ZONING CHANGE REVIEW SHEET

CASE: C14T-03-0001.01

ADDRESS: Dessau Road

**Pioneer Hill
for Milburn Homes**
DEVELOPMENT PLAN
PHASES OF DEVELOPMENT

Current Approved TND Land Use Plan

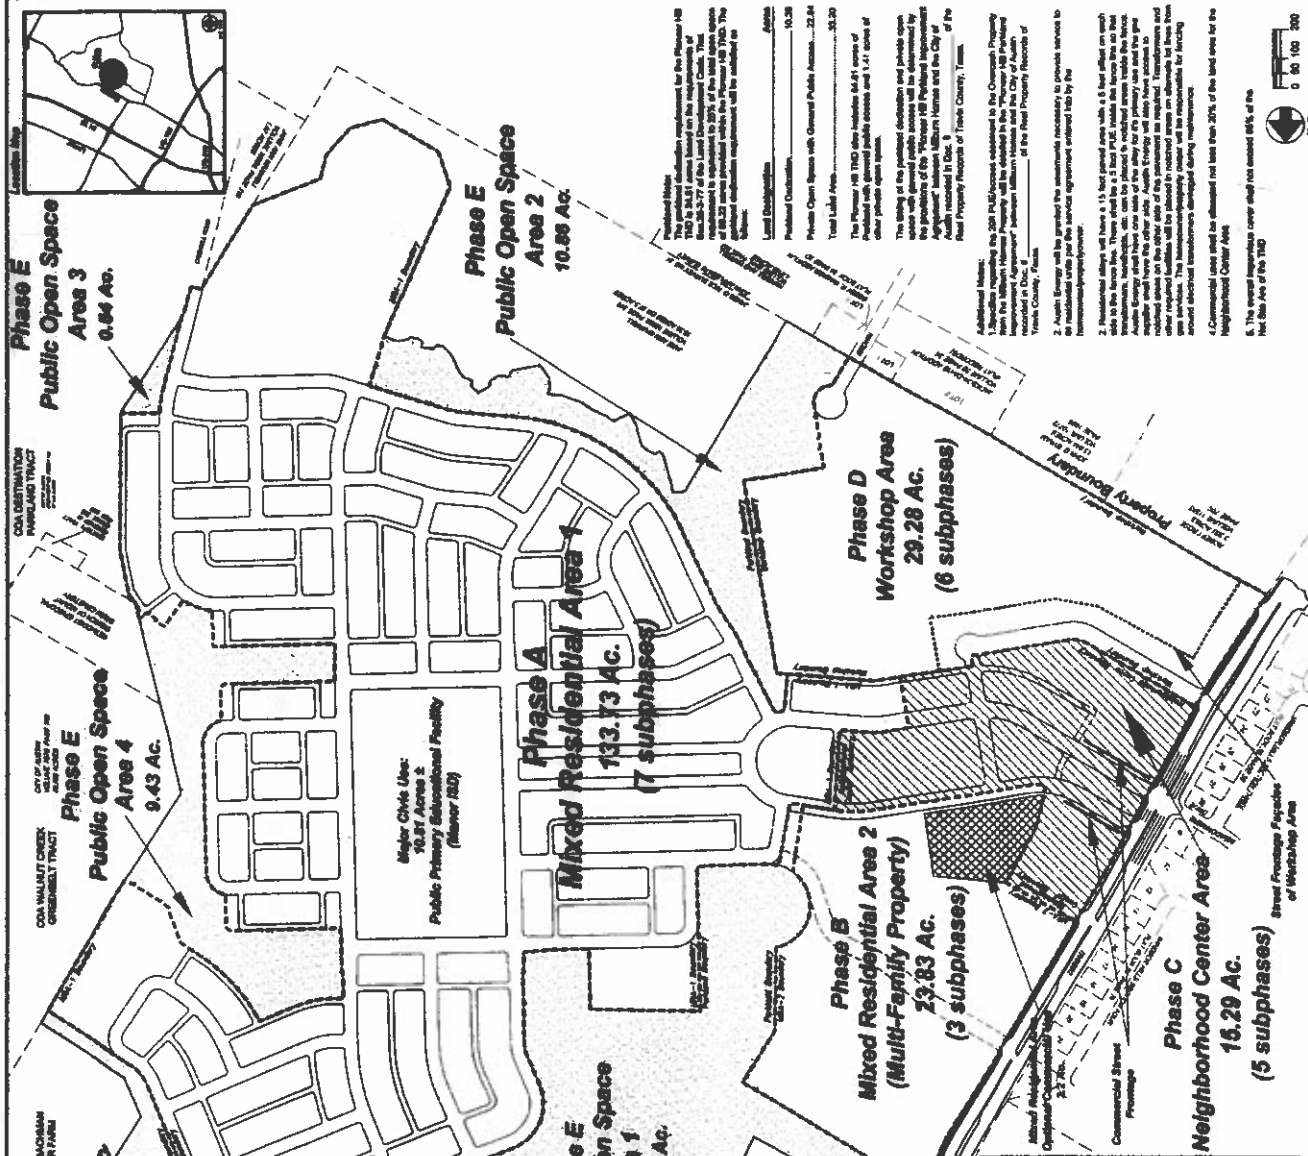
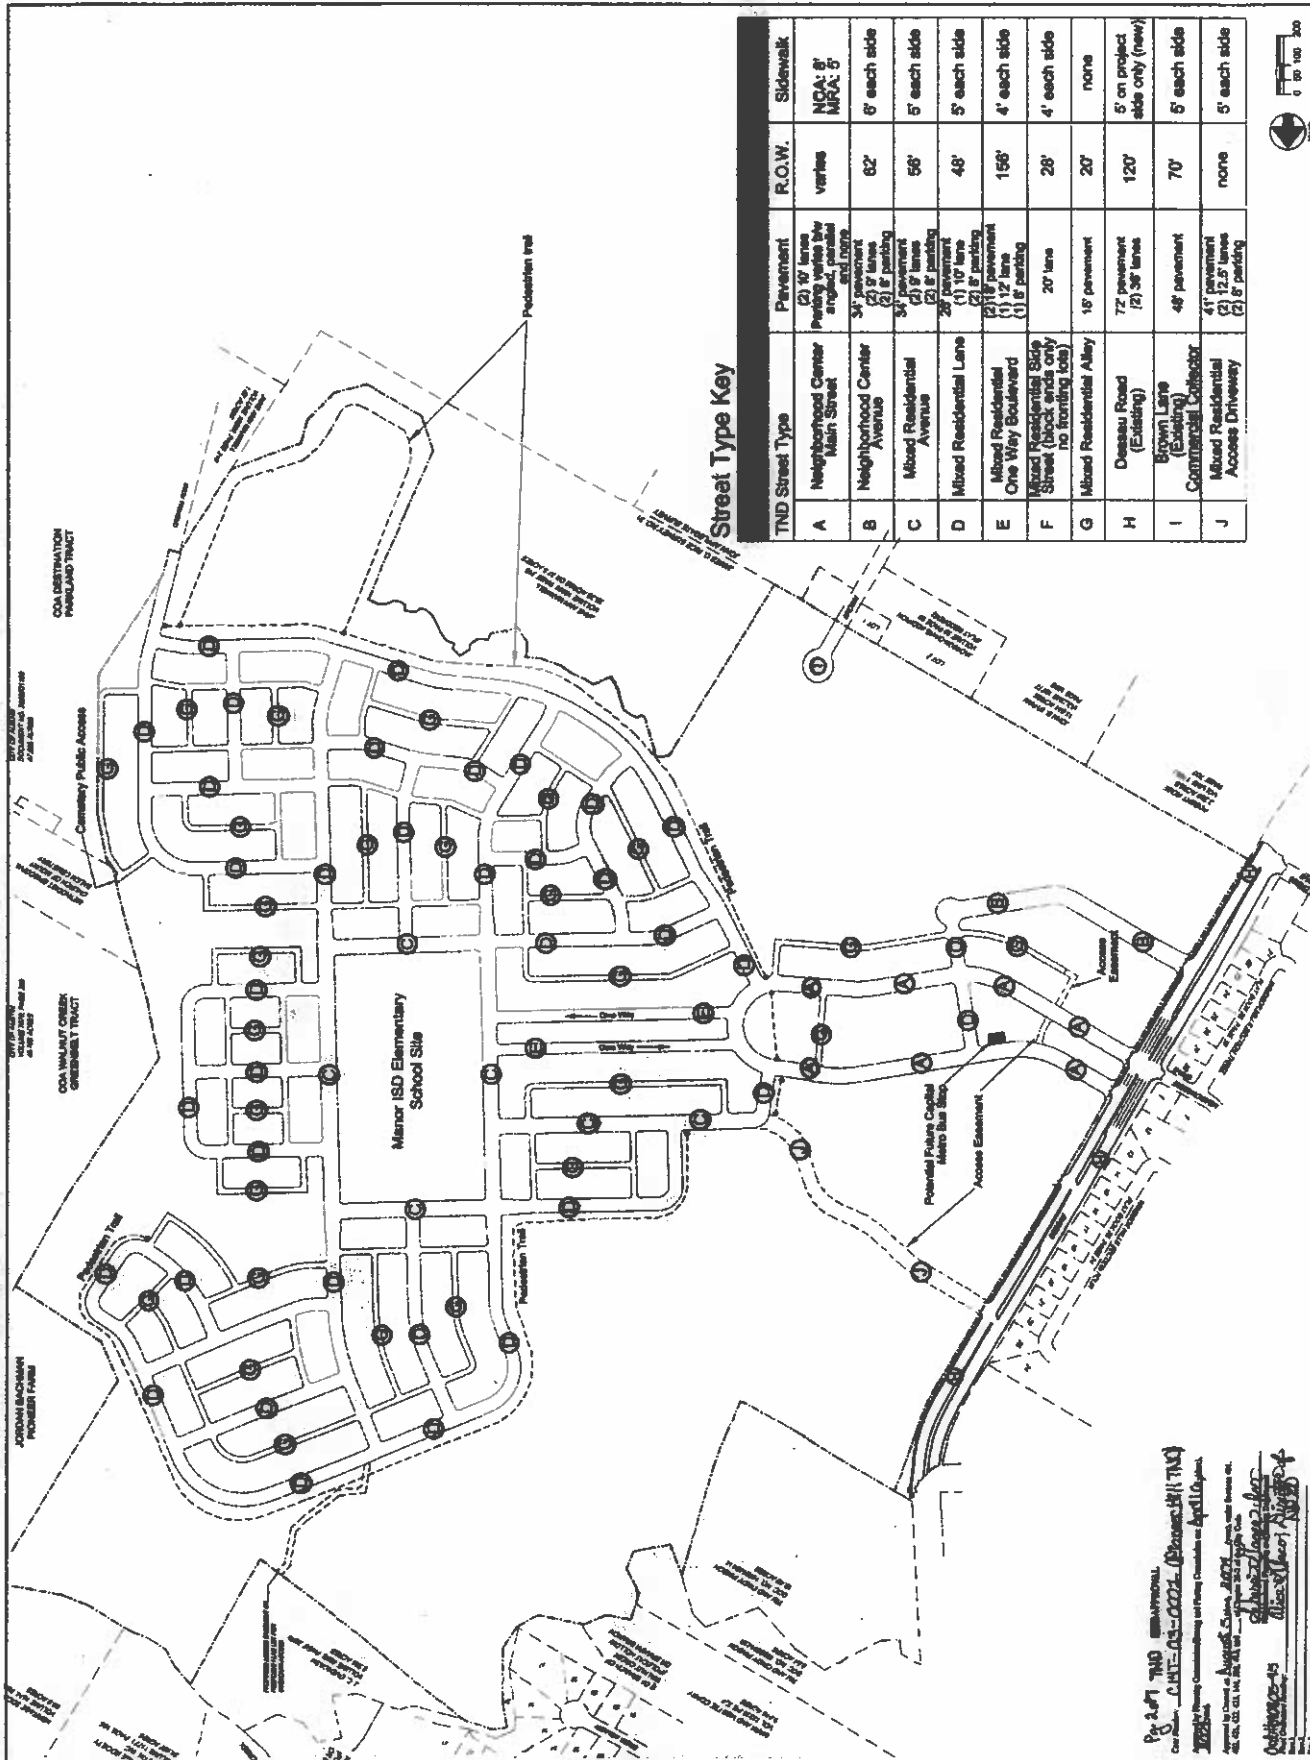
Ordinance §	Title	As Approved (Existing Plan)	Requested Modification (Revised Plan)	Applicant's Explanation	Status
25-3-3(A)	Overview	Currently amended to increase allowable TND area to 278 acres	No modification to TND size as amended but request to change land plan and type of residential "product".	Applicant changed the mix of homes based on its experience with other TND-type master planned communities it currently has under development in Central Texas. Applicant believes the proposed changes and housing product mix and traditional community components (including parkes, retail and commercial uses) meets the "spirit" of the TND and adds to the variety of the housing types and price points vs. the as-approved plan.	Applicant believes that it and city staff are in agreement on the current land concept plan and product mix
25-3-3(C)	Overview	...A square in required in the Neighborhood Center Area (NCA)	Delete in its entirety	The changes to the land plan have reduced the boundary of the NCA. There are areas of open space remaining within the NCA and the TND is surrounded by open space.	This additional request is based on the land plan which has been under review by the city since February, 2008.

25-3-29	NCA and MRA Uses	Currently provides for an elementary school site	Applicant's Revised Plan reconfigures this parcel as single family lots and a community park. Applicant relocated the 10+acres to the eastern boundary with better and direct access to the parkland.	The broker-representative for Manor ISD has indicated to the Applicant that the District does not want to purchase the property.	Applicant believes that it and city staff are in agreement to not develop this portion of the site for a period of three years starting as of the date with the first CO is issued in Pioneer Hill. If, within that time period, there is a bona fide offer and acceptance from a civic-use purchaser for the site, Applicant will process a zoning change to permit the civic use. Otherwise, Applicant will develop the site as illustrated on the Revised Plan (lots and park).

25-3-52(G)	Subdivision Layout Requirements	Currently amended to provide that every lot in the MRA1 should abut an alley.	Applicant requested the ordinance to read: "Only lots fronting the main boulevard are required to have alley access."	Based on Applicant's several years' experience with its other TND developments in Central Texas, Applicant has determined that the alley-accessed single family homes are significantly less marketable and more expensive to construct in a suburban greenfield vs. front-garage homes. Additionally, alley accessed homes limit the size of the backyard and generally increase impervious cover. By deleting some of the alley-accessed lots, impervious cover is decreased and Applicant will have a more marketable and affordable development.	Applicant and city staff are in agreement with the current proposed lot layout with includes alley access on the majority of the lots within the TND.

25-3-76(5)	Open Space	At least one square shall be located in the NCA. The required square shall be at least one-half acre in a TND of 100 acres or less and one acre in a TND of 100 acres or more	Delete in its entirety	The proposed changes to the land plan have reduced the boundary of the NCA. SEE ABOVE 25-3-3(C)	This additional request is based on the land plan which has been under review by the city since February, 2008.
25-3-81(C)	Roadway Design	Currently the ordinance provides that the Director may approve innovative roadway designs that are not listed in the TND Criteria Manual	The proposed new land plan requests the deletion of the northern Right In/Right Out only entrance/exit.	The As Approved plan does not permit left-turns out of the community for residents/traffic intending to travel southbound on Dessau. This is inconvenient and creates a hazardous road condition if this traffic chooses to use the median break further north on Dessau. Applicant has updated the TIA for Pioneer Hill to reflect this change as well as the other changes within the development affecting traffic flows	City Transportation staff has been given a copy of the updated or amended TIA based on the changes to the current land plan.

Ordinance §	Title	As Approved (Existing Plan)	Requested Modification (Revised Plan)	Applicant's Explanation	Status
25-3-103	Location of NCA:	Modified to provide that at least 80 percent of the units in the Mixed Residential Area must be within 2000 square [emphasis added] feet of a Neighborhood Center Area boundary.	Applicant believes this ("square feet") to be a scripting error and is requesting it be modified to read: At least 75 percent of the units in the MRA must be within 2000 linear feet of a NCA boundary.	The original ordinance called for 90% of MRA within 2000 linear feet of NCA. When it was amended in 2004, it was inadvertently changed to read 2000 square feet. This is not possible. In addition, the proposed new land plan changes the NCA boundary. Applicant is requesting the ordinance be modified to provide that at least 75% of the units in MRA be within 2000 linear feet of the NCA boundary.	This request was included in Applicant's original modification request but has not been addressed in writing by city staff.

TR2 Item 1	"25-3-3(A) Staff will recommend this request so long as the land use modification has been incorporated into the amended TIA."	
ZN2 6/17/08 Comment	"The staff and the applicant will simply have to agree to disagree..."	Applicant agrees to disagree.

ITEM ID	STAFF COMMENT	APPLICANT RESPONSE
ZN4 6/17/08 Comments	"The staff is willing to compromise by recommending that the Manor ISD Primary School Site be held...."	Applicant does not agree to hold this site for a "period of five (5) years from the date that the first home receives a certificate of occupancy..." as recommended by staff. Applicant is agreeable to designating this as a "civic site" for a period (after which the site will <i>revert</i> BY RIGHT to the use/plan illustrated on the latest land plan <i>without</i> an amendment) that expires the later of: (a) 36 months from the date the first home is CO'd or (b) the date the 225 th home is sold to a third party homebuyer by Applicant. Applicant cannot subject the plan to another variance process which is unpredictable, especially considering the length of time that will pass before the possible change will be made. Therefore, the site must revert BY RIGHT to the lot layout and park use as portrayed in the plan as submitted. The <i>other alternative</i> acceptable by Applicant is to have the site approved as submitted and then in the event the site is sold as a civic use site, then the site will go through the variance process to change it from residential/park to civic use. Given the unpredictability of the public process once residents live in the community (as well as expected changes in the Council), Applicant believes the above alternatives are reasonable and appropriate.

Order A
Land Use Plan 1

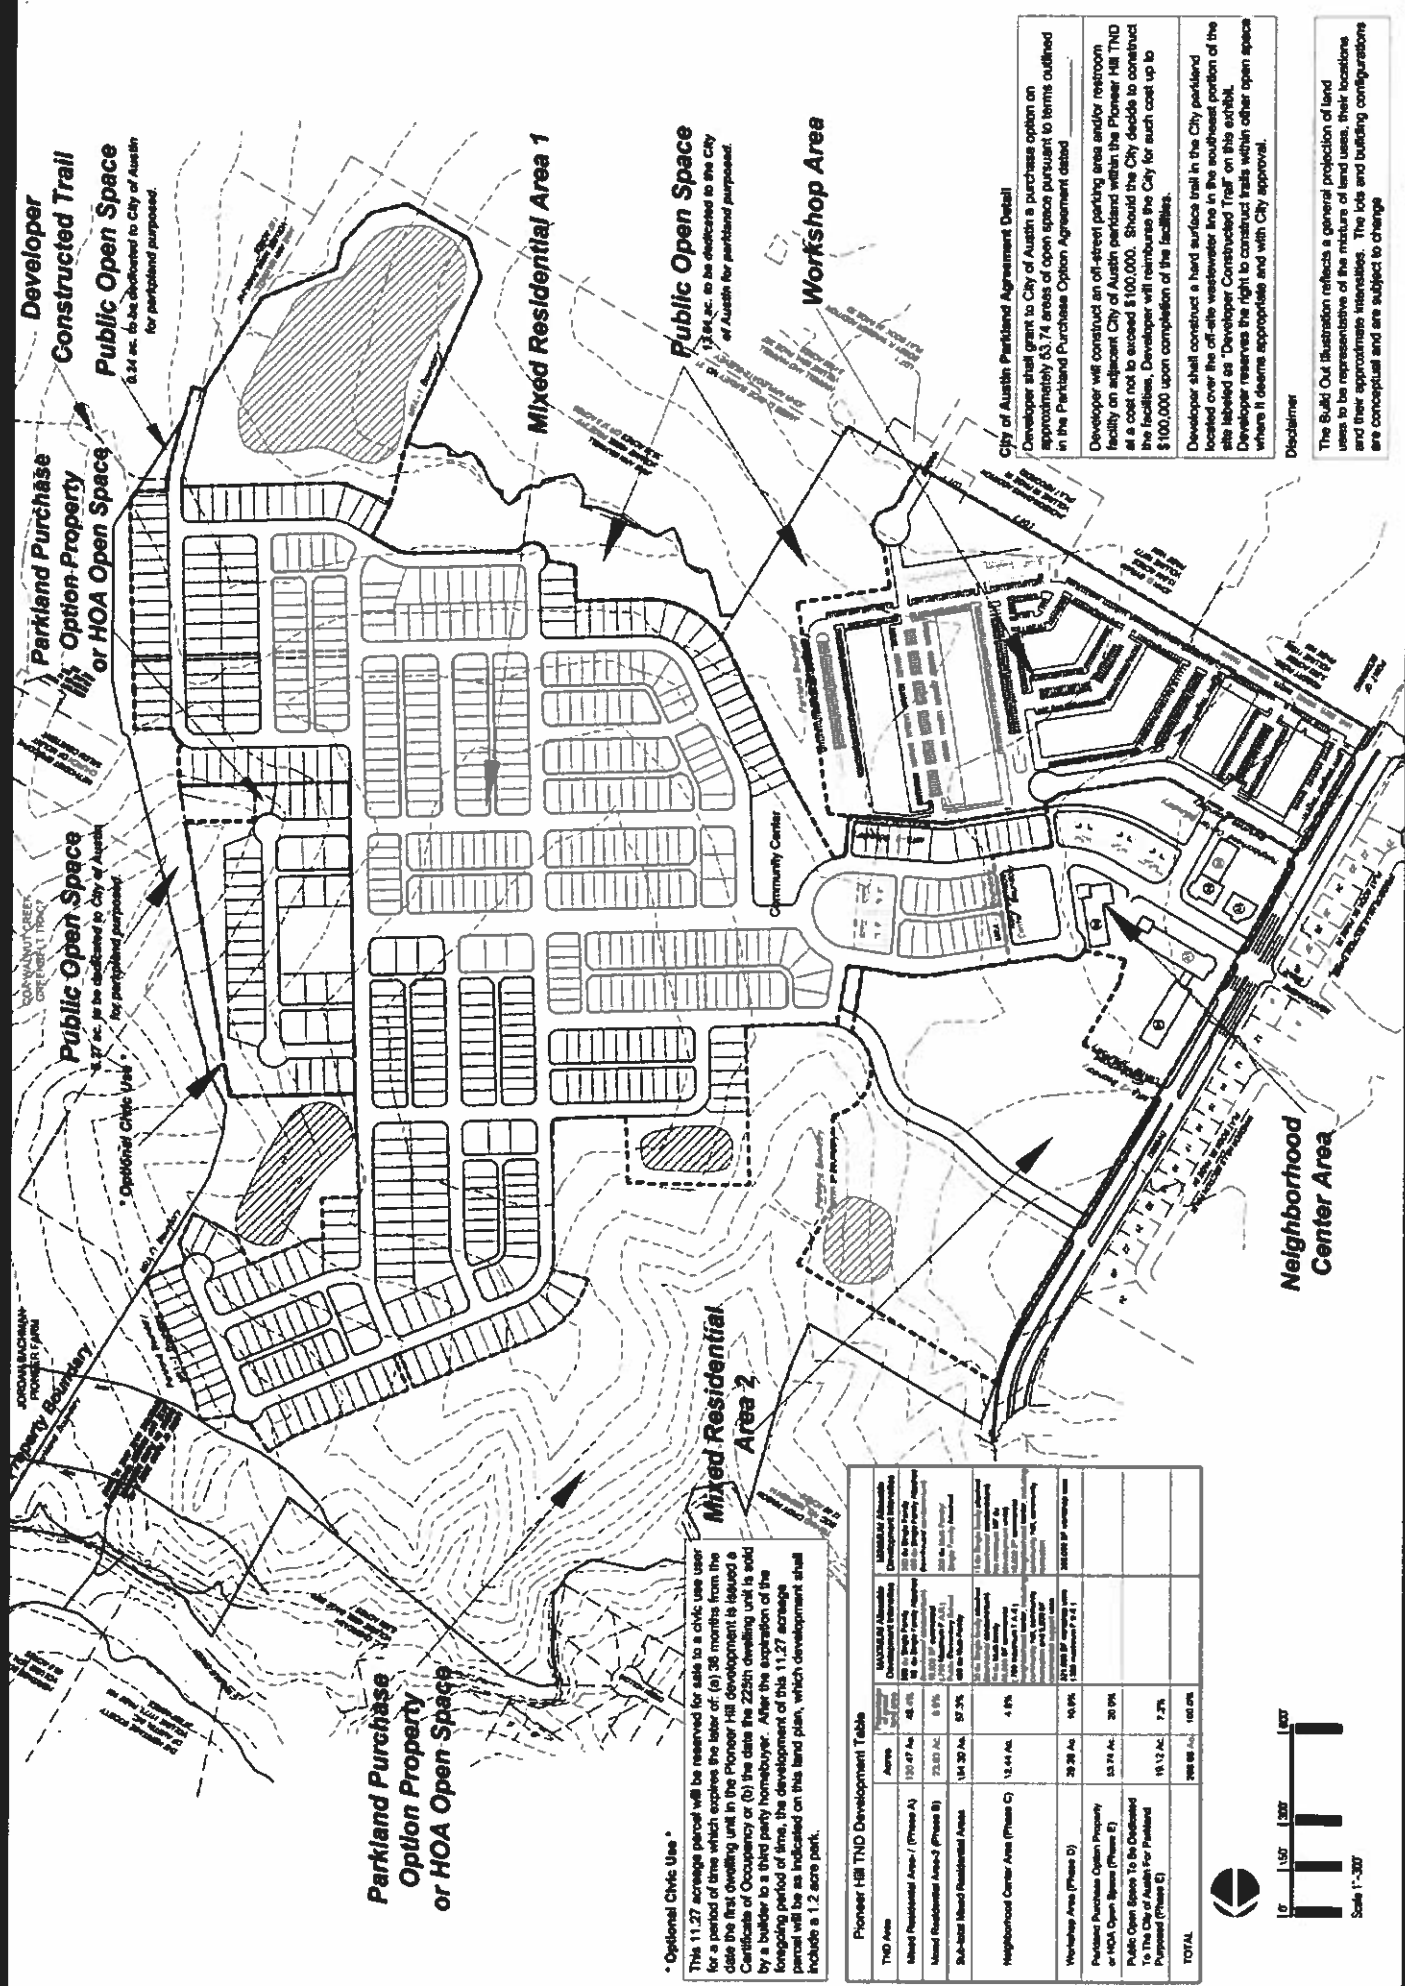
In the event that the applicant requests a variance after the five year period to remove the civic designation for this site, then the staff recommends that a 1.5 acre portion of the Major Civic Use site in the MRA-1 be kept as open space to offset the reduction in Private Open Space along the main boulevard of the TND. This will allow for a focal point within the TND, even if a civic use is not constructed on the rest of the approximately 11-acre site.

In addition, the staff recommends the alterations proposed by the Parks and Recreation Department in response to the applicant's request to delete the open space requirement for a one acre square in a TND for 100 acres or more. These changes are shown on the revised land use plan (Please see Attachment B).

This 11.27 acreage parcel will be reserved for sale to a civic use user for a period of time which expires the later of: (a) 36 months from the date the first dwelling unit in the Pioneer Hill development is issued a Certificate of Occupancy or (b) the date the 225th dwelling unit is sold by a builder to a third party homebuyer. After the expiration of the foregoing period of time, the development of this 11.27 acreage parcel will be as indicated on this land plan, which development shall include a 1.2 acre park.

City of Austin Parkland Agreement Detail
 Developer shall grant to City of Austin a purchase option on approximately 53.74 acres of open space pursuant to terms outlined in the Parkland Purchase Option Agreement dated _____.
